Field Installation of Capacitor Bank Potential Transformer T6 - TVPT Kit AK00018-000-01

Document No. ALN192

Field Installation of Capacitor Bank Potential Transformer T6 - TVPT Kit

1. Introduction

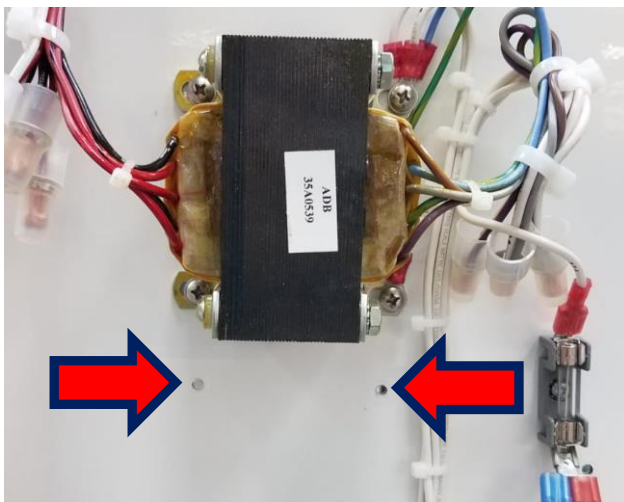
1. Remove power to the CCR, following all applicable regulations and safety procedures.
2. Remove top panel of the CCR, or left side panel for stacked CCRs.
3. Locate transformer T4 on the component plate. There are two different procedures, depending on the T4 transformer:
 - a. For Small T4 on 2.5-10 kW CCRs (ADBSG part number 35A0539)
 - i. Locate and remove the two (2) **TOP** retaining screws of T4.

- ii. Replace these screws with the ones provided in the kit (64A0191/10).
 - iii. Locate the two (2) additional threaded holes below T4.

- iv. Insert the remaining screws provided in the kit (64A0191/10) into these holes.

b. For Large T4 on 15-30 kW CCRs (ADBSG part number 35A0546)

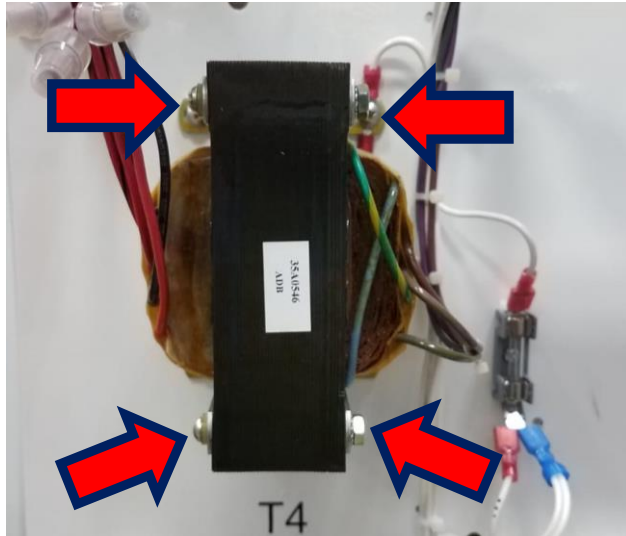
i. Locate the four (4) retaining screws of T4.

ii. One by one, replace them with the ones provided in the kit (64A0191/10).

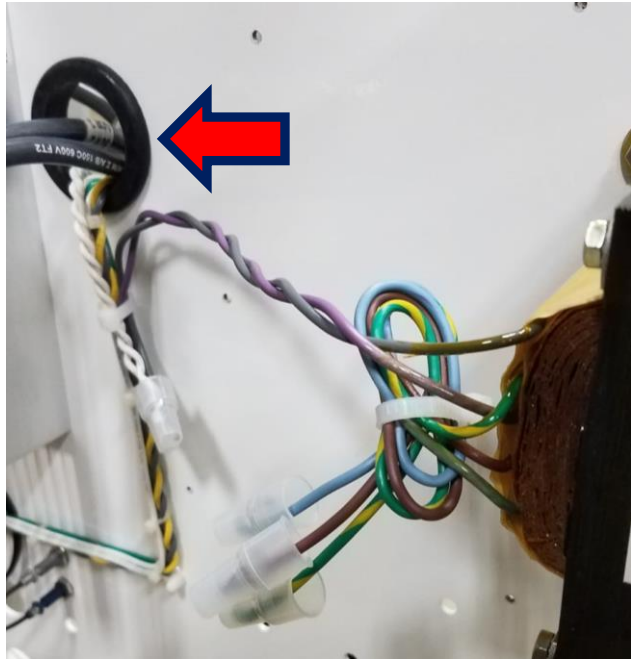
4. Verify all grounding wires are attached as they were before.
5. On the back side of the component plate, locate the screws that were installed on step 3.

6. Mount the potential transformer (35A0796) on these screws and attach with provided lock-washers (66A0038/4) and nuts (65A0347/2).

- a. Make sure all lock-washers (66A0038/4) are used to avoid PT from becoming loose from CCRs vibration.
- b. Make sure RED and BLACK wires are oriented towards the edge of the component plate as shown below.

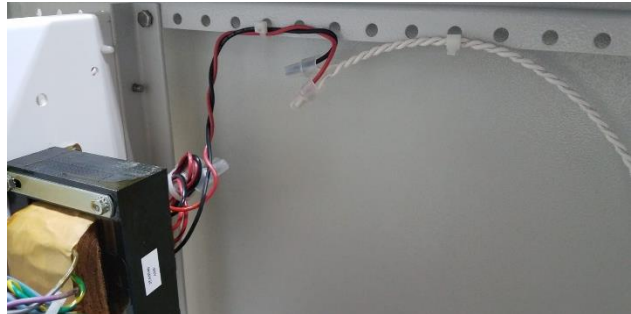
7. Route VIOLET/GRAY extension wiring from the back of the component plate towards the front through the component plate's hole.

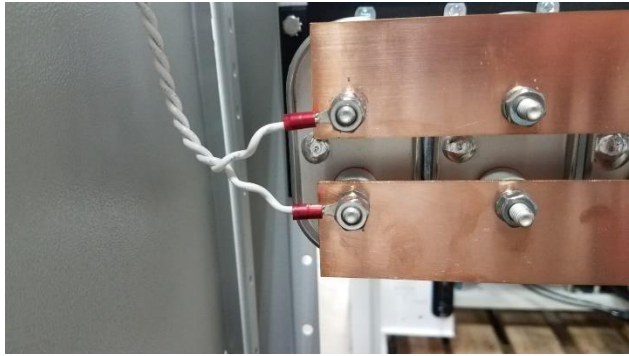
8. Route RED/BLACK extension wiring towards the capacitor bank on the back of the CCR.

Connect ring terminals to the capacitor bank using the provided 1/4 hardware (65A0015/24 and 66A0038/6). Make sure not to overtighten the nuts as damage may occur to the capacitor. The use of a counter wrench to hold the existing nut is recommended.

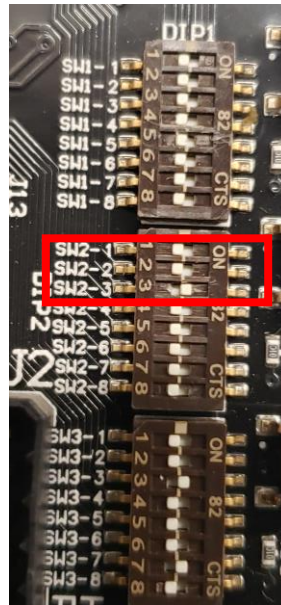
9. Replace existing URC4 control PCB with the one provided in the kit (44A7693).

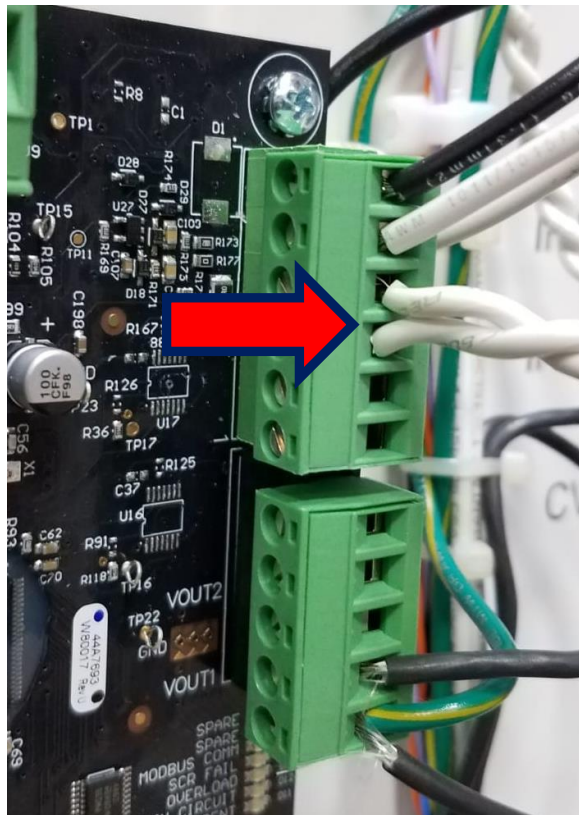
- a. Configure DIP switch settings according to the type, size and specifications of the CCR. Make sure to enable the PT feature by turning ON Dip switch **2-3**, and turning off **2-1** and **2-2**.

10. Connect the potential transformer's VIOLET/GRAY extension wires on terminals J7-3 and J7-4 of the URC4 board using the provided connector. If URC4 already has a connector and wiring on J7 just add the VIOLET/GRAY extension wires to terminals 3 and 4 of the existing J7 connector (polarity insensitive). In this case, discard the connector provided in the kit.
